RE: REQUEST FOR CHANGE ORDER FOR PERMIT # 15272

SITE LOCATION: 5550 G.M.D.

SUBJECT: POST BASE SUBMITTAL
Durante Park Restrooms

JOAN M. DURANTE PARK RESTROOM BUILDING

COL. BASE DETAIL

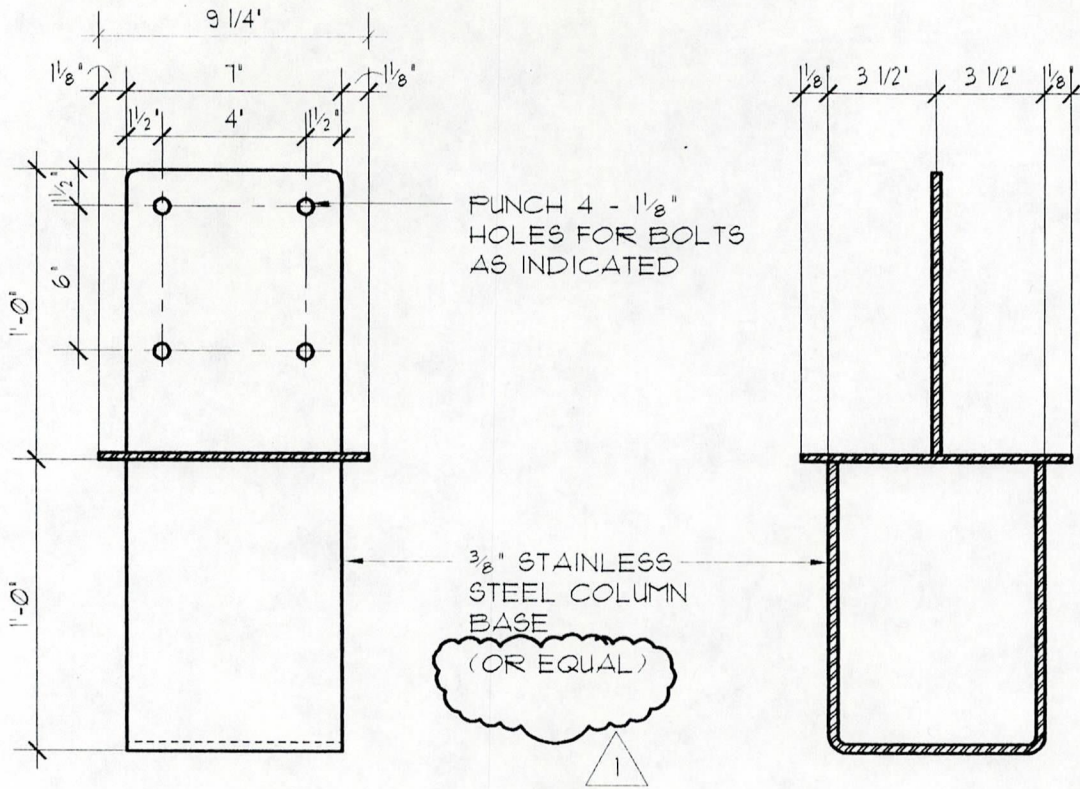
CHANGED ORDER FOR NEW BASE PLATES
SIMPSON BRACKET EQUAL TO ORIGINAL
CB 1010

Please have you staff review and accept this product for the column post bases on the Durante Park restroom project. As you know we are providing all of the materials for the Contractor to perform the work for the construction of the facilities. Due to costs involved and product availability we are suggesting the use of the Simpson CB1010 column base anchors as an approved "OR EQUAL" alternate to the detail in the amended plans attached.

Approved

PROJECT NUMBER: **98145**
PROJECT NAME: **Durante Park**
- Restroom

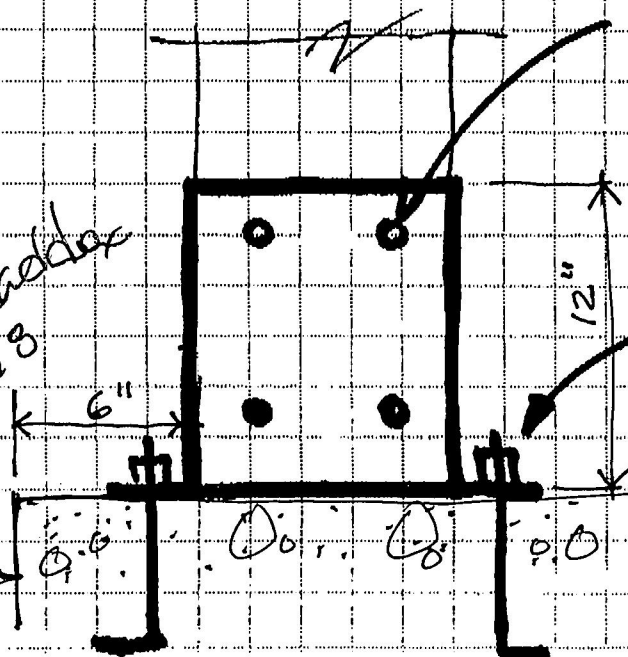
leave 2 sides open to avoid trapping water @ post base.

welded plate assembly
3/8" THK.
(HDG after fabrication)

4 - 1/8" holes for bolts (as original shown).

4 - 3/4" A.R.
(12" embedment plus 3" hook).

Approved Building file

PROJECT NUMBER: **98145**
PROJECT NAME: **Duval Park**
- Restroom

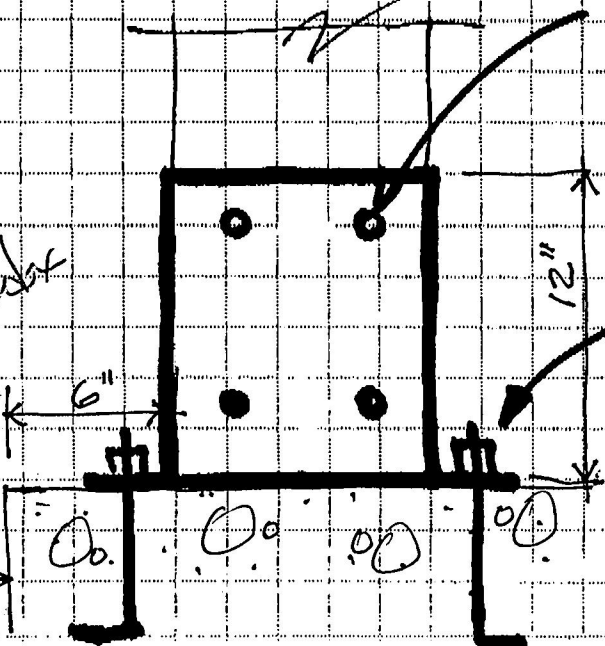
leave 2 sides open to avoid trapping water @ post base.

PT 10x10

welded plate assembly
3/8" THK.
(H.D.G. after fabrication)

4 - 1/8" holes for bolts (as original shown).

4 - 3/4" A.B.
(12" embedment plus 3" hook).

PROJECT NUMBER: **98145**
PROJECT NAME: **Duval Park**
- Restroom

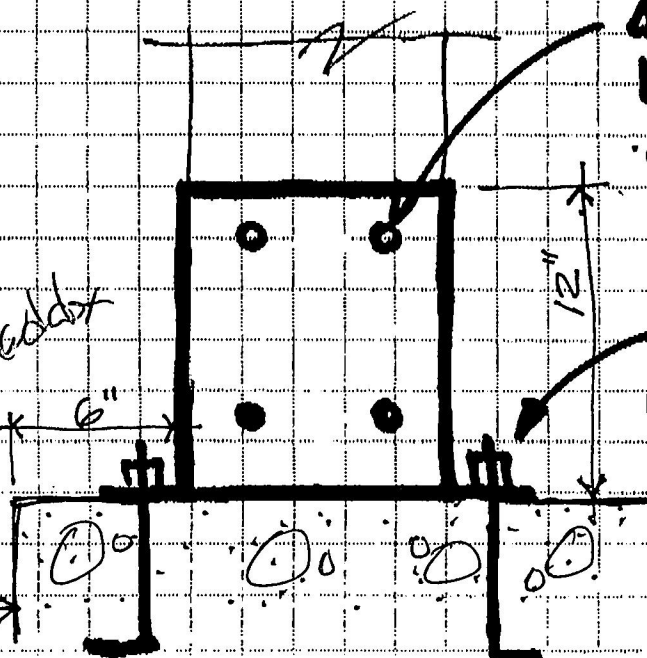
leave 2 sides open to avoid trapping
water @ post base.

welded plate
assembly
3/8" THK.
(H.D.G. after
fabrication)

4 - 1/8" ϕ holes for
bolts (as original
shown).

4 - 3/4" ϕ A.B.
(12" embedment
plus 3" hook).
